**PLANNING COMMISSION
SITE/SUBDIVISION PLAN
CASE SUMMARY**

**10.21 ACRES, WESTSIDE OF CLIF KINDER BOULEVARD
COTTAGES AT BURNSIDE FARM
BURNSIDE FARMS ASSOCIATES, LLC**

Subject Property:	10.21 acres, Westside of Clif Kinder Boulevard, TMS#19100-06-20
Council District:	4
Proposal:	Request site plan review of an 60 lot single-family residential housing development
Applicant:	John Stephenson, Burnside Farm Associates, LLC
Proposed Use:	Single-family Residences
Staff Recommendation:	Approval with staff comments.

CITY AGENCY COMMENTS FOR SITE/SUBDIVISION PLAN REVIEW

BURNSIDE FARM ASSOCIATES, LLC
 THE COTTAGES AT
 BURNSIDE FARMS
 SITE PLAN
 RICHLAND COUNTY, CITY OF COLUMBIA, SOUTH CAROLINA

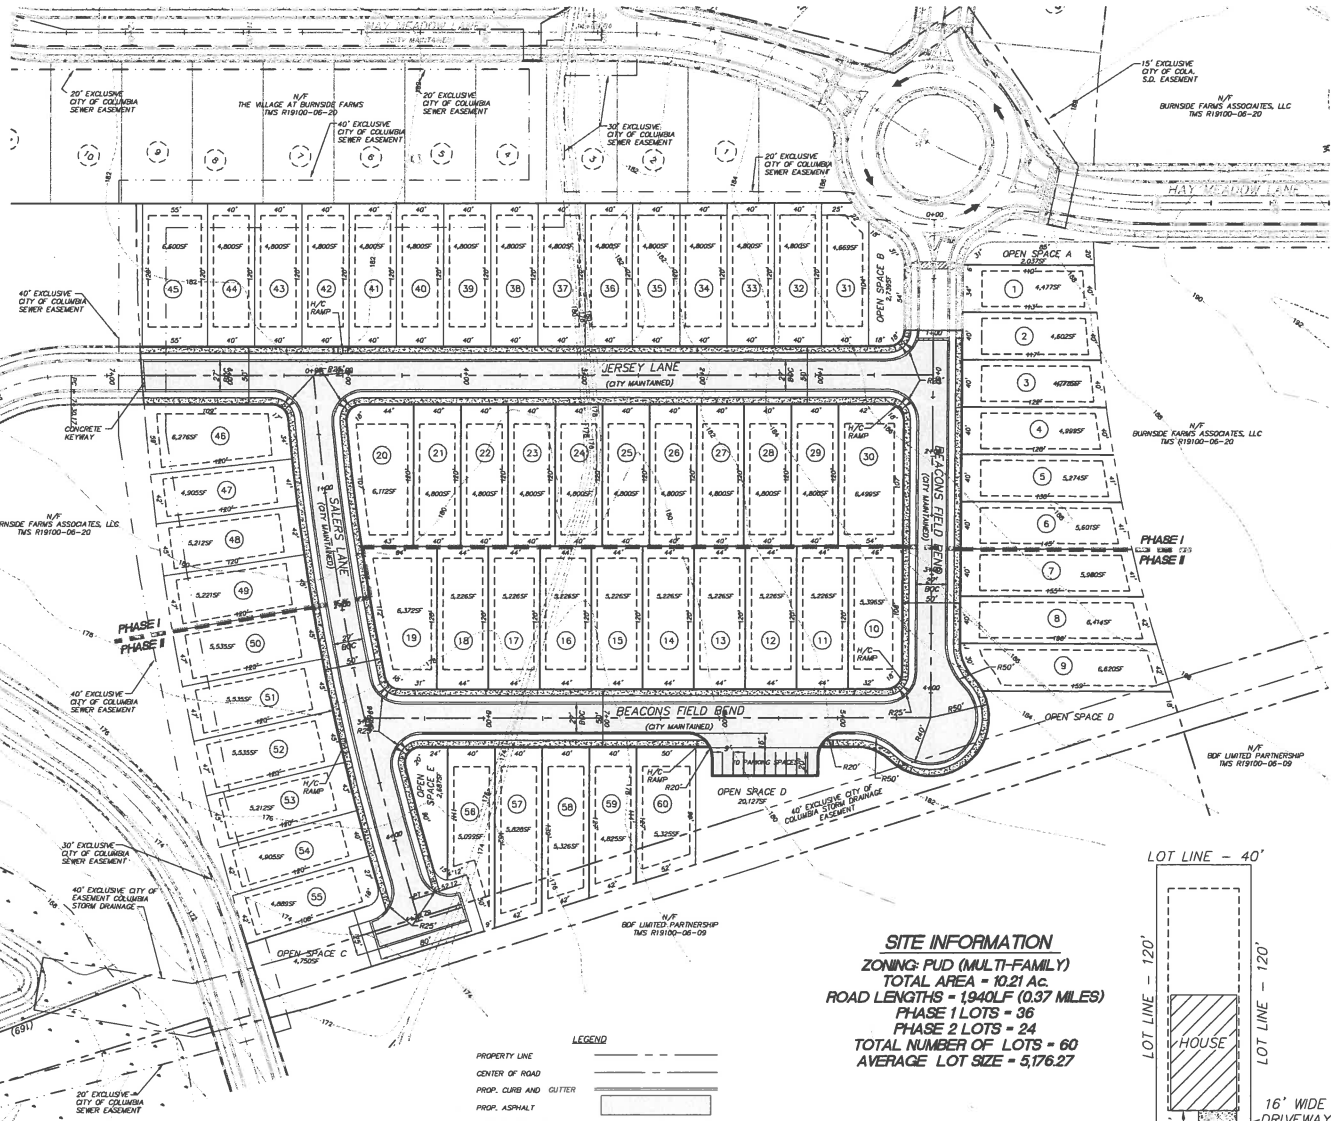
John Fellows, Planning	<p>Recommend approval with conditions:</p> <ol style="list-style-type: none"> 1. Sidewalk Crossings: a handicap ramp should be positioned to allow for crossing in each direction. i.e. three-way intersection would have 4 ramps, a four way intersection would have 4 ramps a T or curve would not have any ramps. 2. Plans do not indicate dimension of sidewalk. Min. width of the sidewalk is to be 5 feet. 3. Plans do not indicate the dimension of the border area between the curb and sidewalk. The minimum width is to be 4 feet. 4. Due to the small lots and traditional neighborhood development style of this development all phone, electrical, and other above ground utility boxes, towers, etc. shall be located in areas that will not be in front yards of lots. Locations could be side yards, open space lots, rear yards, or side yards. A plan for such cabinets should be submitted with any

easement documents to the city prior to construction.
K. Brian Cook, Zoning Administrator	Recommend approval with condition: 1. Must meet all requirements of the PUD.
Johnathan Chambers, Land Development Administrator	Recommend approval with conditions: 1. Planning Commission approval includes the naming of Jersey Lane, Salers Lane and Beacons Field Bend all of which have been approved by Richland County E911.
Robert Harkins, Plans Examiner	Recommend approval.
Scott Rogers, Utilities	Recommend approval with conditions: 1. Any needed upgrade, extension or relocation of City utilities must be provided by the developer. 2. Any privately owned/maintained utilities or permanent structures cannot be located inside City of Columbia utility easements. 3. Water mains, sewer mains, water meters that are 4" or larger or any privately maintained utilities will not be allowed inside public right-of-ways or under sidewalks without an approved encroachment permit and written approval from the City Engineer. Coordination between the Civil Engineer, Architect and Mechanical Engineer to allow room for these utilities on the developed property is strongly encouraged. 4. If sewer flows for this project result in flows of 4,000 gallons per day or above calculations must be submitted to the City's Engineering department to determine how the proposed project will affect the City's sewer system. Depending upon the effects of the projected flows this project may or may not be approved. If required, these calculations should be submitted to the Engineering department as soon as possible. 5. Lot 45 may be unbuildable based upon location of sewer easement.

David Brewer, Traffic Engineering	Recommend approval with conditions: 1. Due to roadway width, recommend on-street parking be prohibited on one side of street. 2. Power grid will require any street lighting to be fed underground. If decorative lighting is desired, it must be installed to City specs (available from Traffic Engineering) and deeded to the City for maintenance. 3. Separate metered power circuits are required for City-maintained decorative street lighting. No SCE&G-leased decorative lighting will be accepted by the City.
David Koon, Fire Department	Recommend approval.
Scott Holder, Land Development Planner	Recommend approval with condition: 1. Trees should not be placed in sight line triangles at road intersections. It is recommended that trees be planted near parking spaces adjacent to "Open Space D" that meet requirement for all parking spaces to be within 40' of the trunk of a shade tree.

Sara Hollar, Forestry	Recommend approval with condition: 1. Once species is approved by Forestry and Beautification and trees planted, provide two year warranty to replace any trees that do not survive.
Michael Jaspers, Stormwater	Recommend approval with conditions: 1. Construction within the storm drainage easement(s) is prohibited. 2. Army Corps of Engineers jurisdiction required on drainage feature running approximately northwest to southeast across the development.
Robert Sweatt, Street	Recommend approval.
John Hooks, Solid Waste	Recommend approval.
John Spade, Parking	Recommend approval.
